FirstEnergy appreciates the opportunity to review & comment on the September 1, 2009 (draft 6.5) technical reference document titled “*Power Plant and Transmission System Protection Coordination*”. We hope our input is useful to the System Protection and Control Subcommittee in its efforts to further improve the document.

Figure 3.2.2 — Coordination between UFLS scheme and Device 24 on Generator

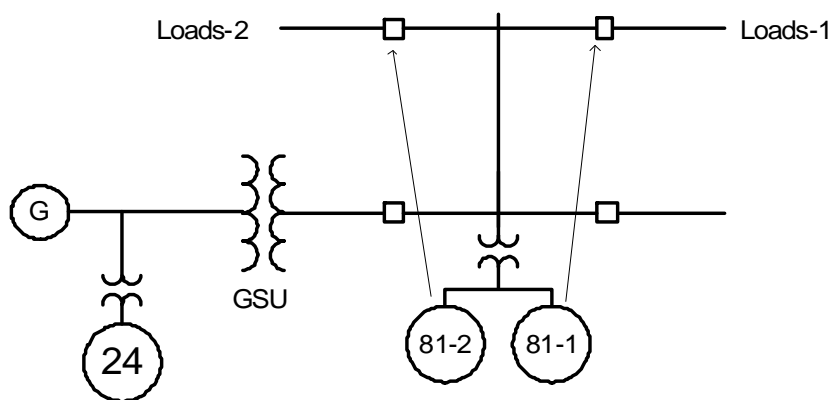
The paper uses Figure 3.2.2 shown below as if this is a typical installation.

It should be stressed that this is not a typical installation. UFLS protection is more commonly applied at the distribution level to trip distribution feeders not transmission lines as shown here.

The SPCS has modified the figure to show a more typical installation in which the UFLS protection is supplied from a potential source on the low-side of a distribution step-down transformer. A similar change has been made to Figure 3.14.1.
